Memorandum to the City of Markham Committee of Adjustment

File: A/39/19
Address: 20 Stone Jug Avenue, Markham
Applicant: Adrian Leandro
Agent: Cindy McPhee
Hearing Date: Wednesday May 29th, 2019

These variances relate to a proposed coach house (accessory dwelling unit) located above an existing detached garage on the subject property (20 Stone Jug Avenue).

1 SITE PLAN
 Scale: 1:100

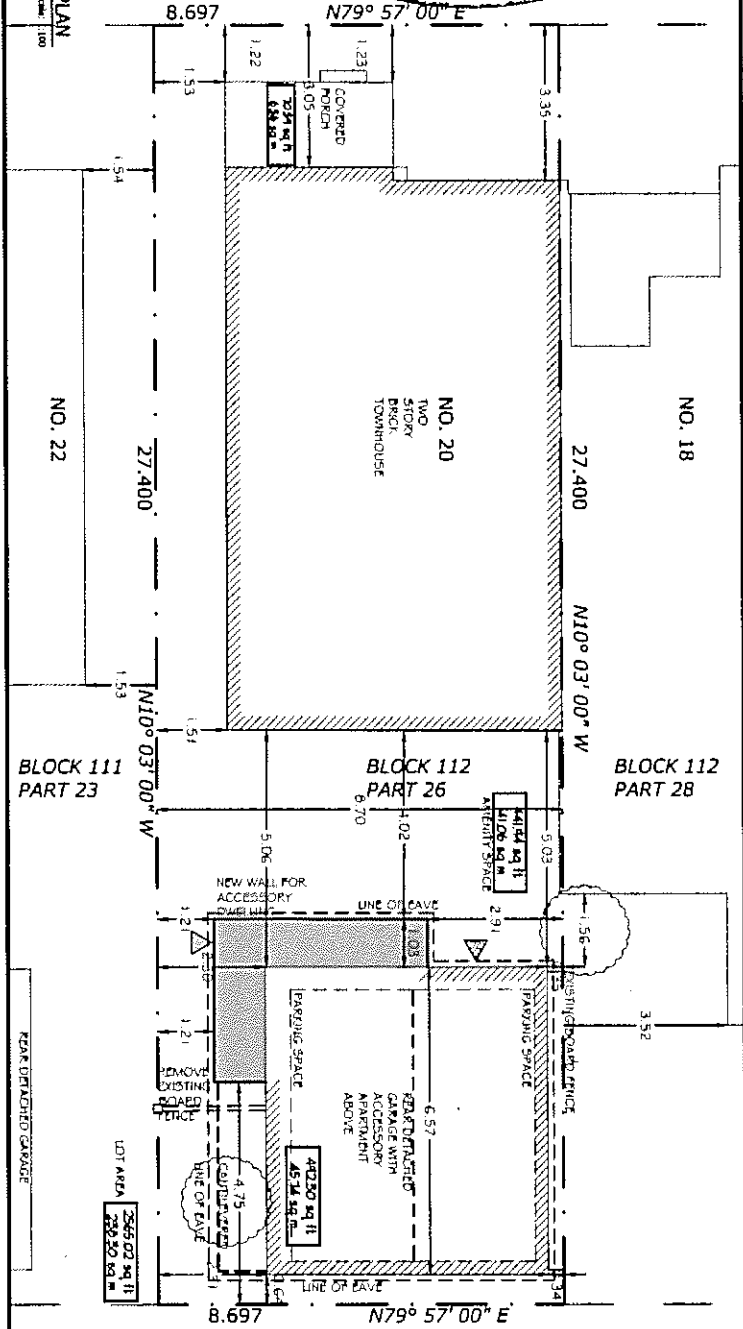
The applicant completed a Zoning Preliminary Review (ZPR) to confirm the variances initially requested. The original submission proposed that the stairs to the coach house would expand the entire width of the garage in the rear yard. Consequently the reduced setback to the main dwelling applied to the entire garage/coach house building. Additionally, the garage/coach house building initially had a proposed lot coverage of approximately 20.9%.

Planning staff had concerns that the proposed 2nd storey coach house addition was too close to the adjacent dwelling unit to the west (18 Stone Jug Lane) and requested that the applicant consider options to mitigate its visual impact. The applicant submitted revised plans on May 22nd,

As noted, staff had concerns with the original proposal, where the 2nd storey coach house addition expanded the entire width of the garage. The applicant revised their plans by removing a portion of the 2nd storey addition within proximity of this adjacent dwelling to lessen its visual impact. Consequently the 1.0 m setback reduction only applies to a 2.91 m (9.55 ft) wide portion of the 2nd storey coach house addition that will not impact abutting properties. Staff are of that this variance request meets the four tests of the Planning Act.

The applicant is requesting relief for a maximum lot coverage of 19.5 percent, whereas the By-law permits a maximum lot coverage of 18 percent. The proposed lot coverage includes a staircase and space for utilities which adds approximate 6.53 m² (70.3 ft²) to the overall building footprint. Staff are of the opinion that the increase in lot coverage will not significantly add to the scale and massing of the dwelling.

2019 where the stairs are within a portion of the rear yard, as shown in Appendix A. The applicant completed a second ZPR to confirm the variances required for revised plans.
